CONSTRUCTION DOCUMENTS

FALCON MARKETPLACE

SF-19-001

75% SUBMITTAL 12-20-18

**SOUTH
ROUNDBOUT
PROFILES**

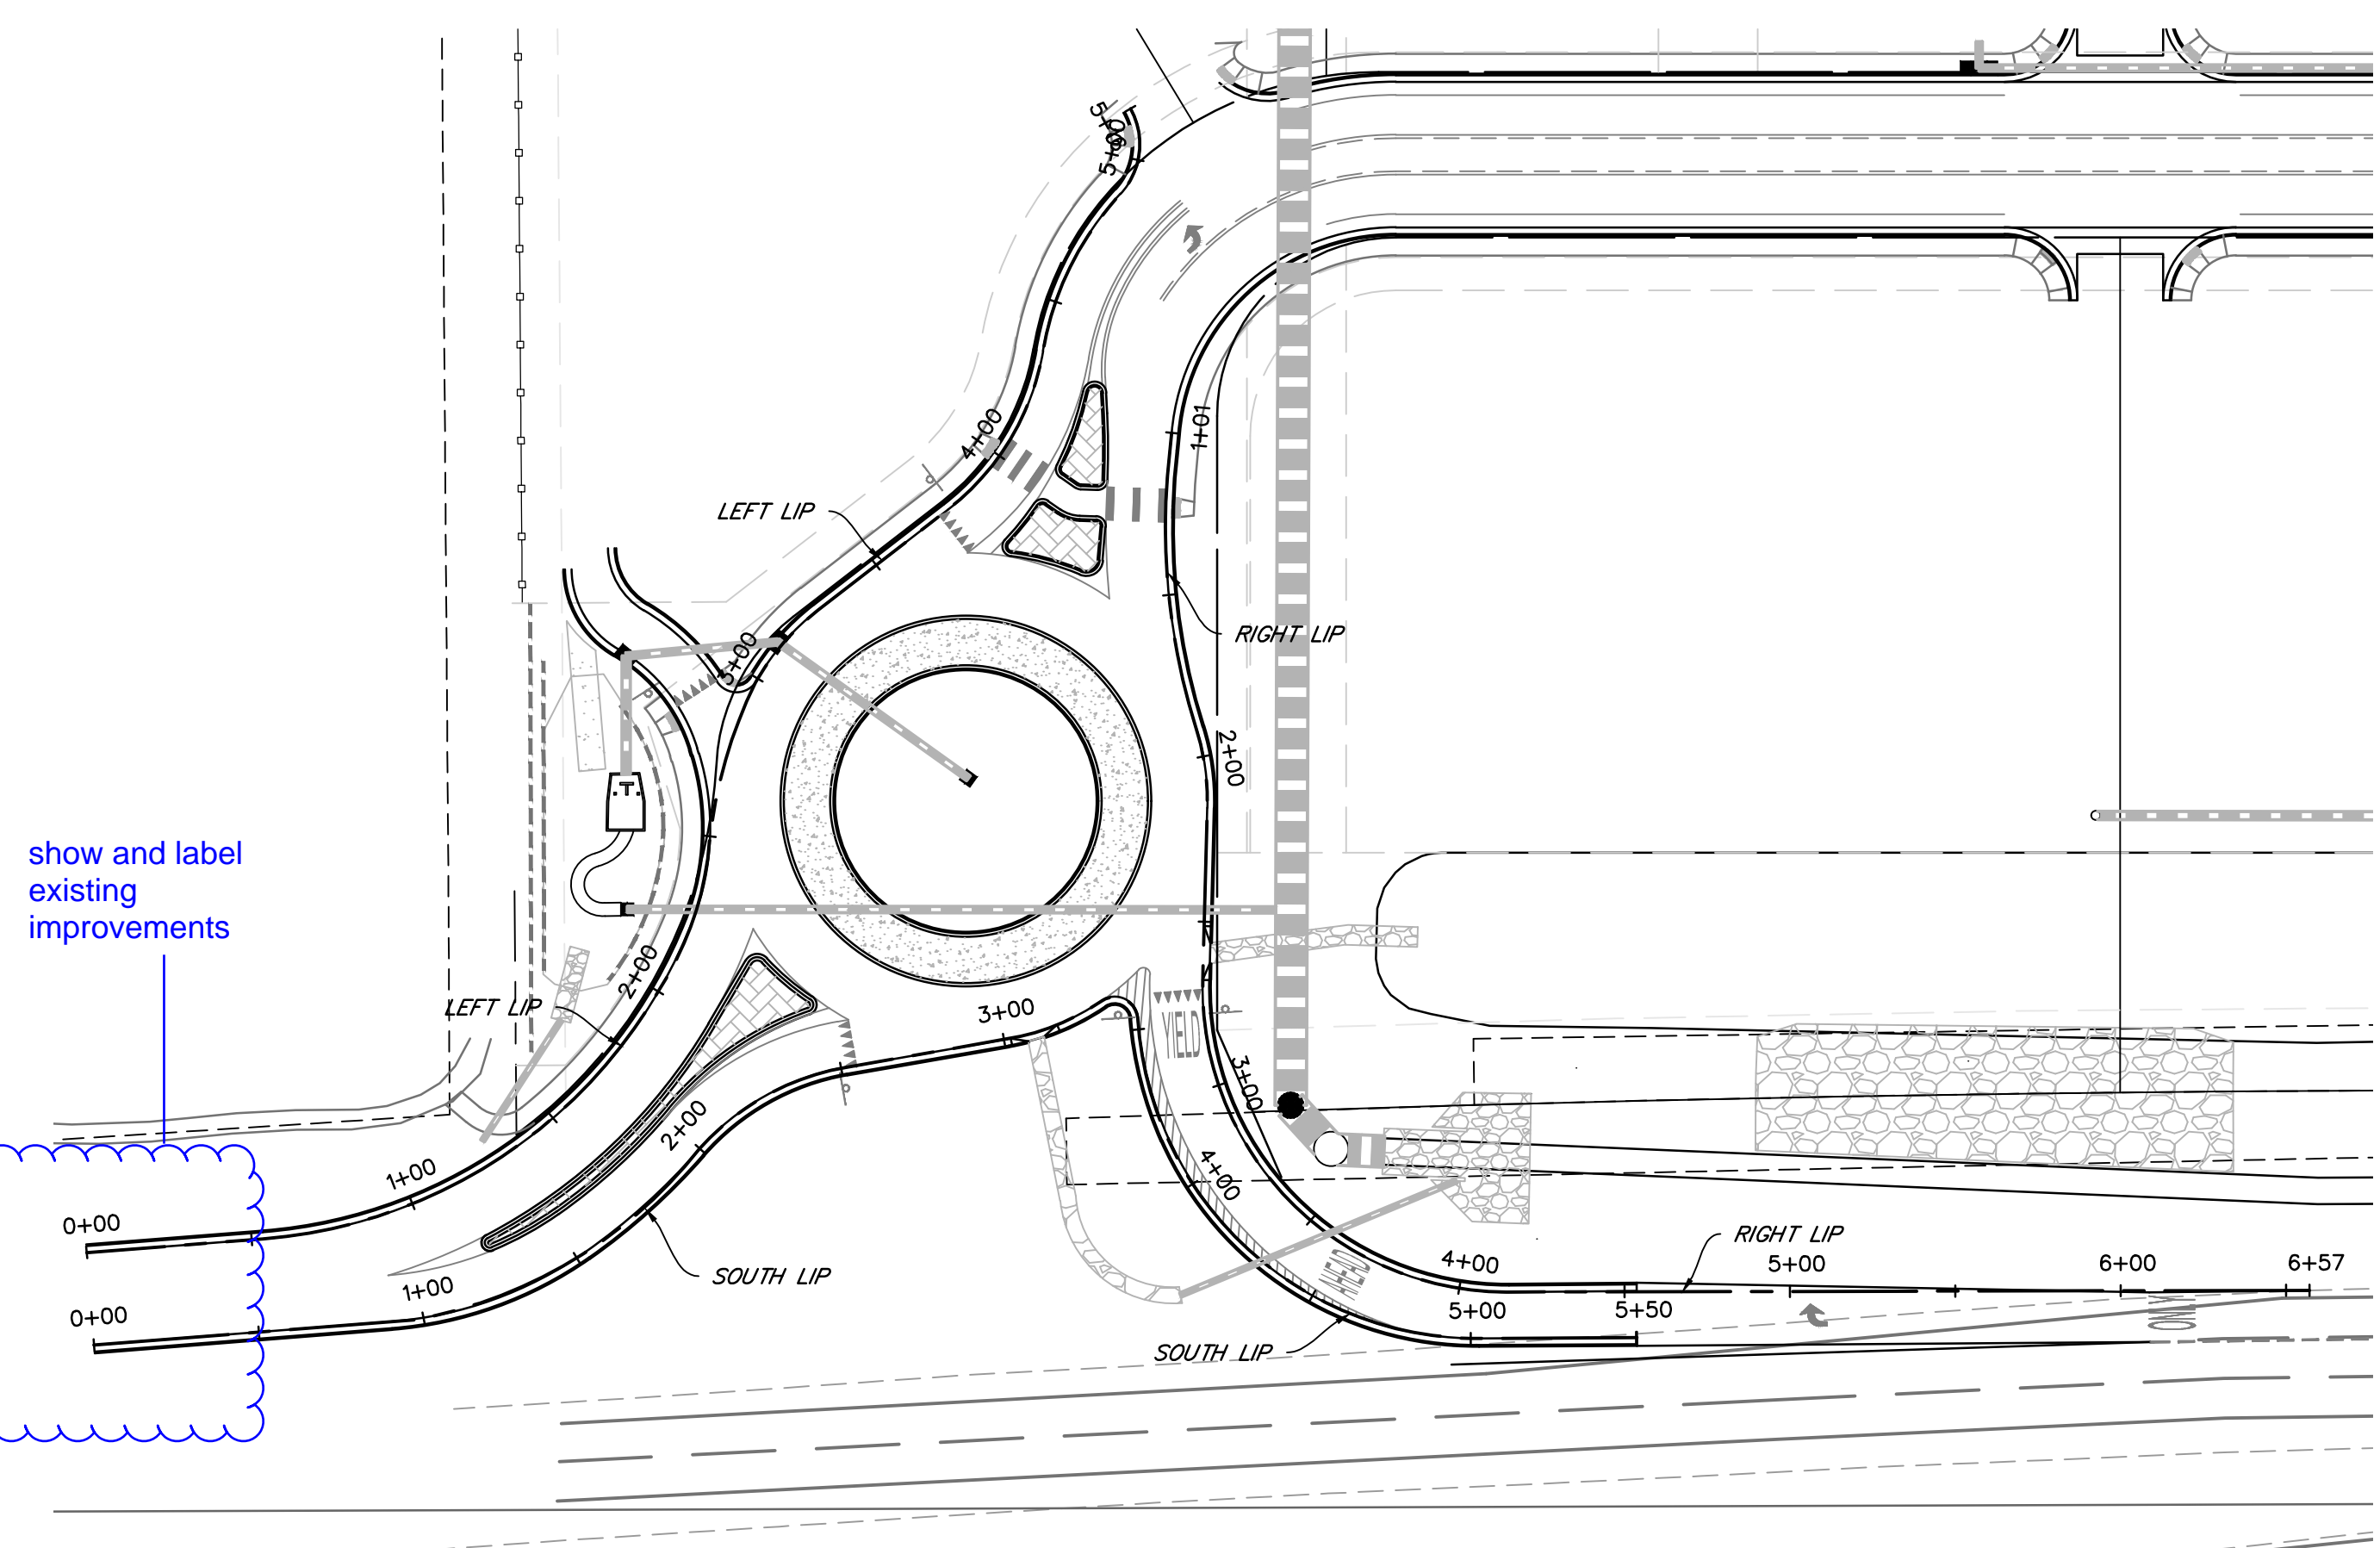
show ROW and property lines
label C&G types

Provide complete
details

Show utilities and easements.

Provide complete
details

label beginning and end stations on all profiles.

why is there a VC here?

Show utility lines and other underground crossings on all profiles.

show continuation of existing grades, with labels, or matchlines calling out continuing sheet on both ends of all profiles

show and label existing improvements

Provide alignment data, survey control.
Show utilities and easements.

TRAFFIC
SIGNAL
PLAN

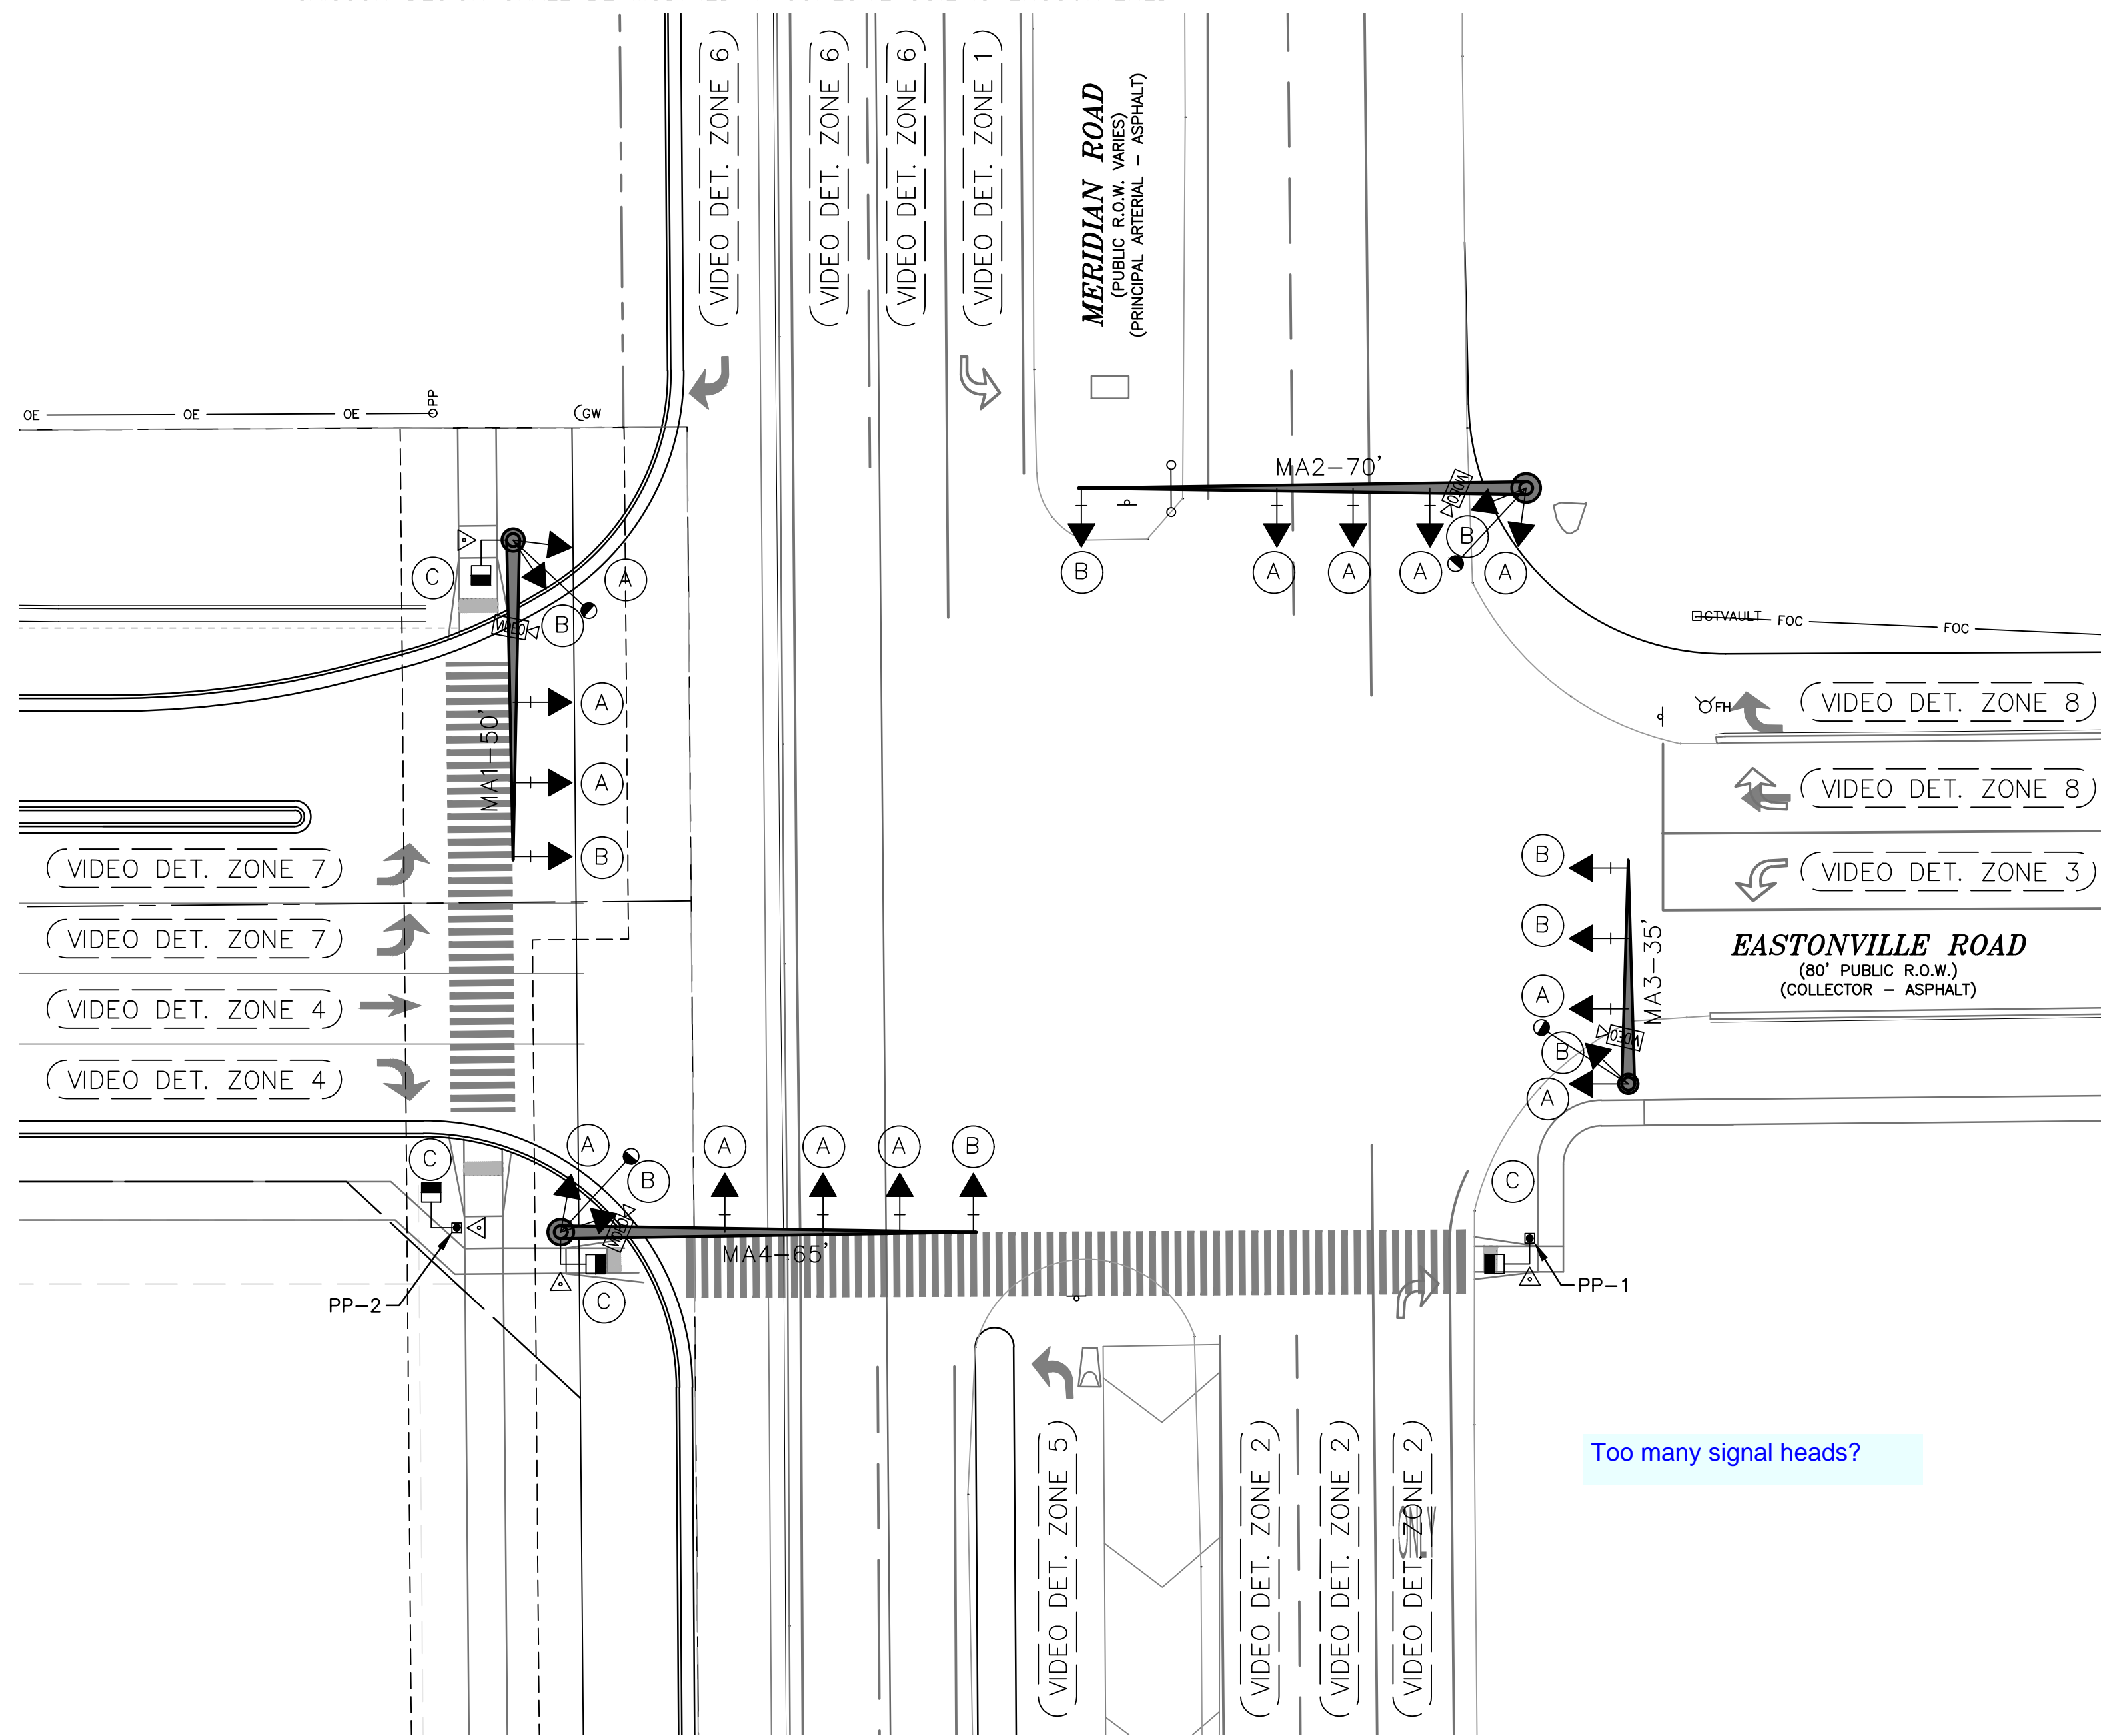
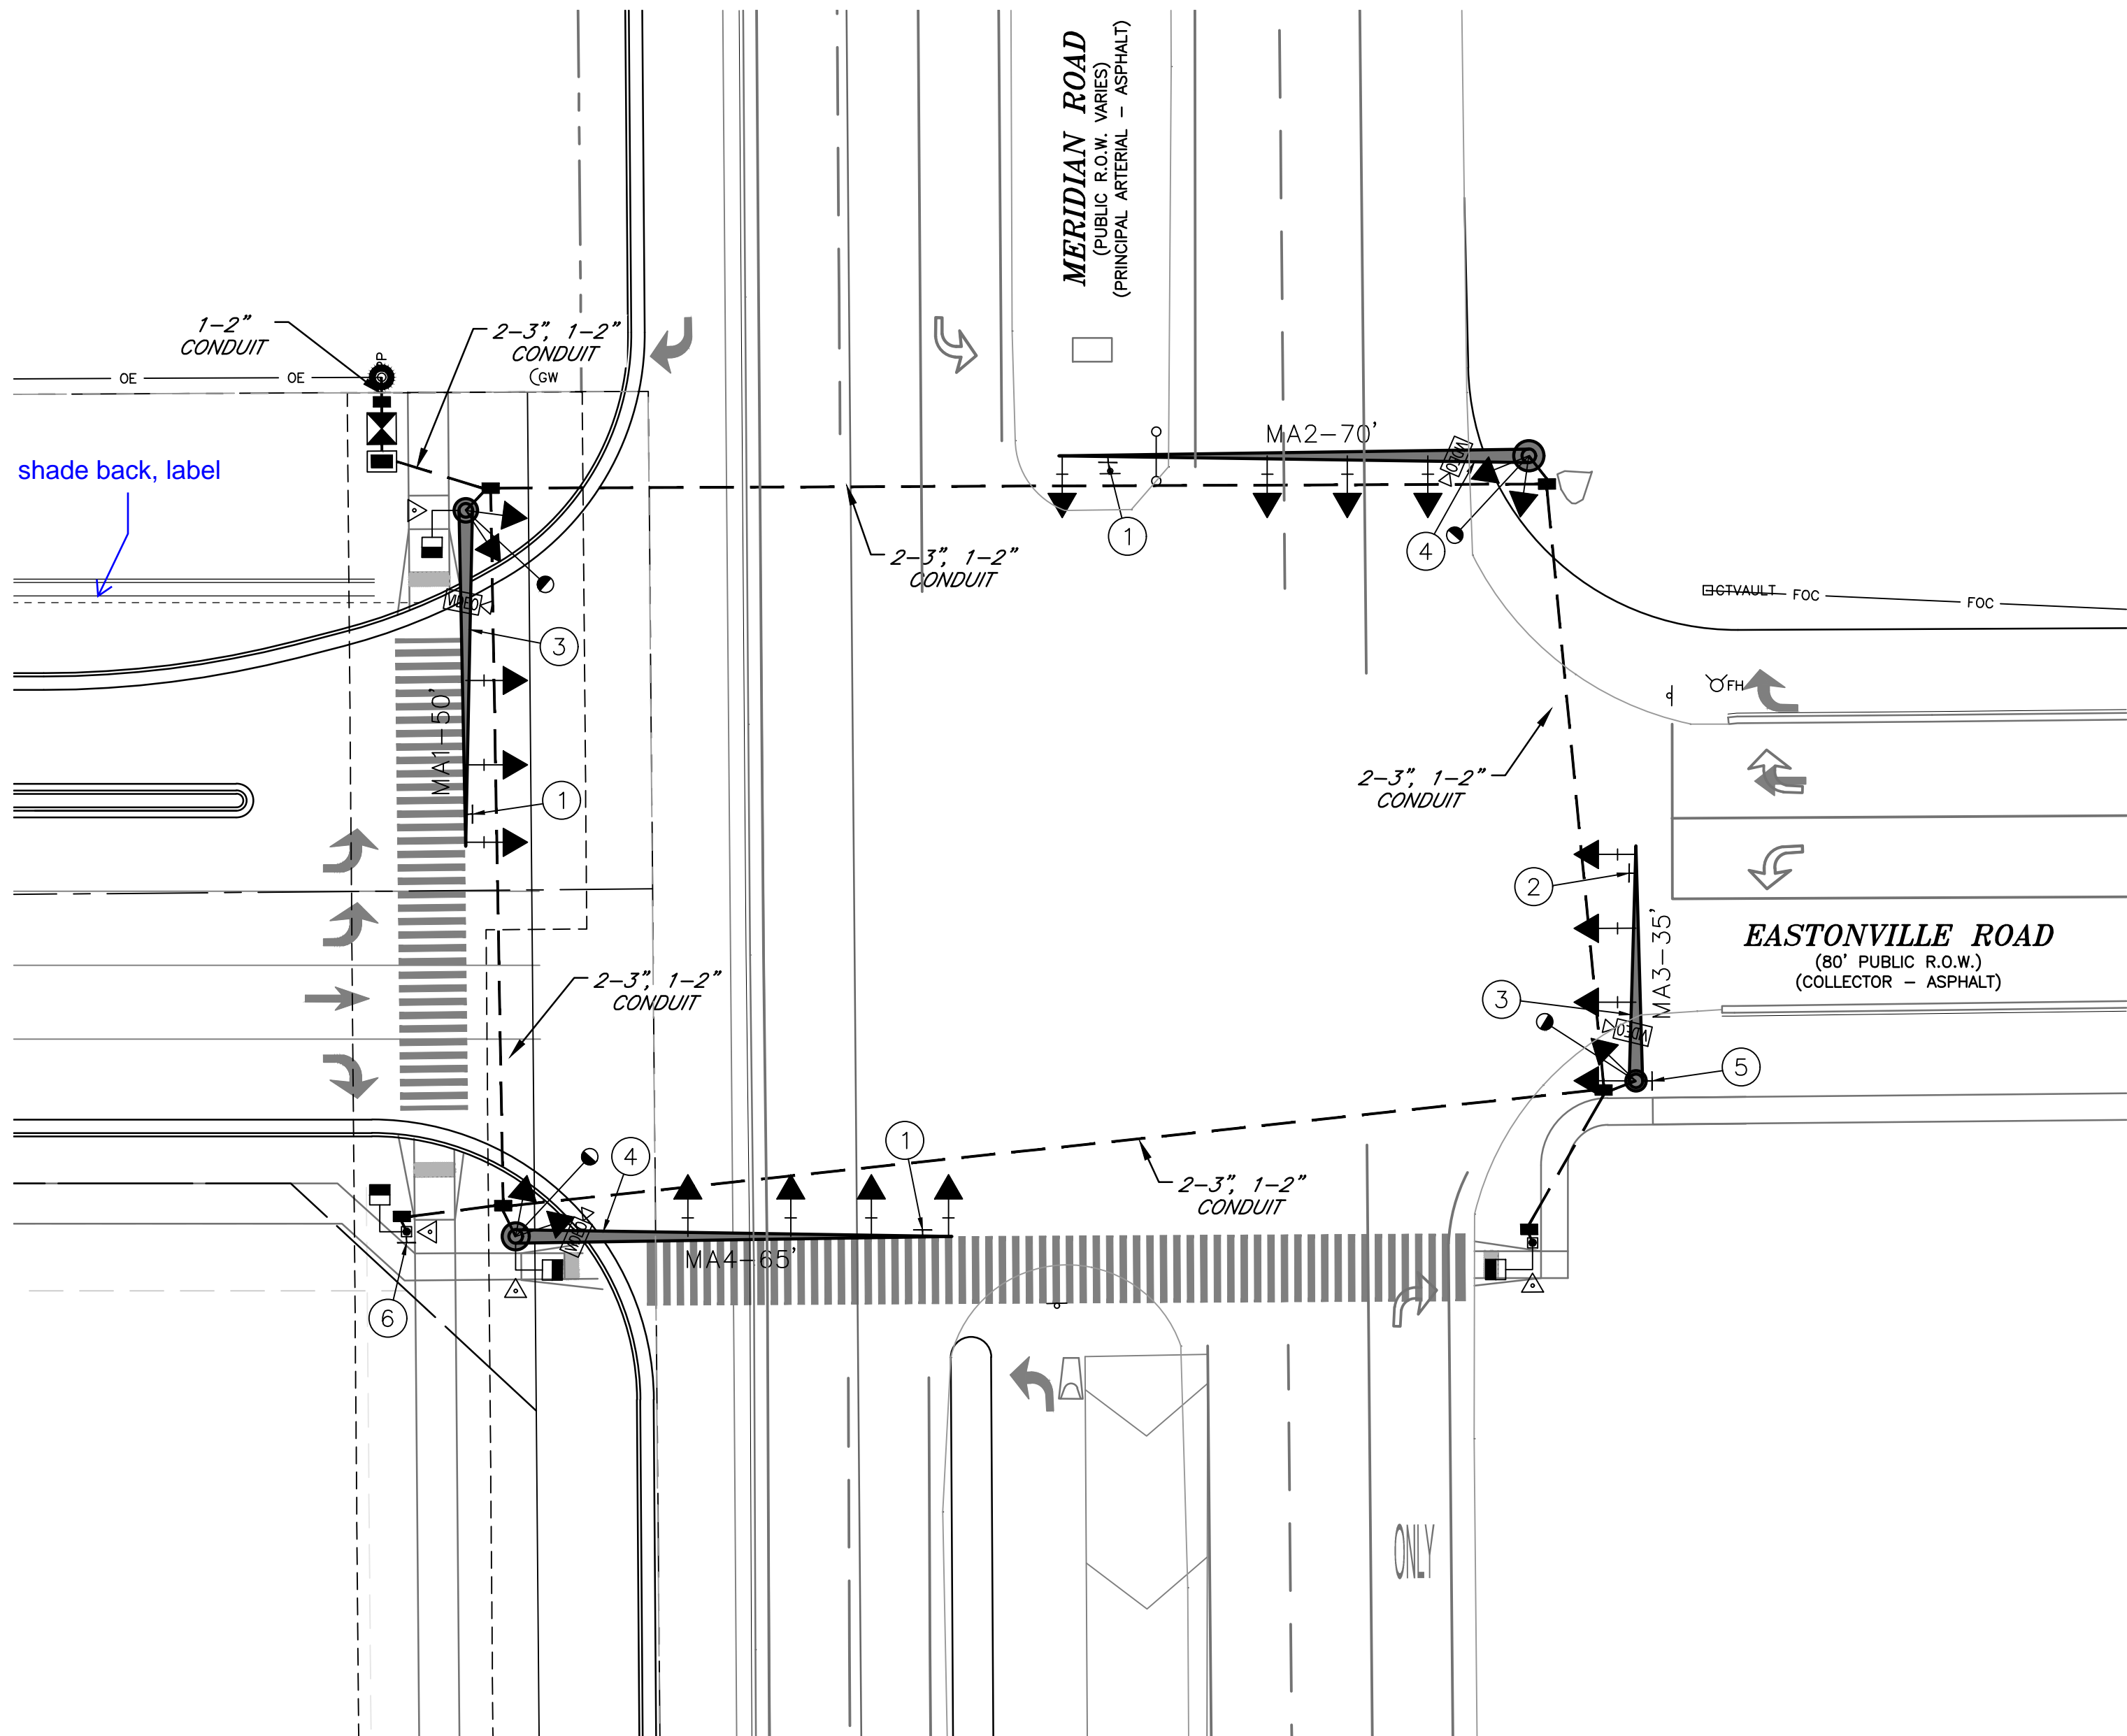
Too many signal heads?
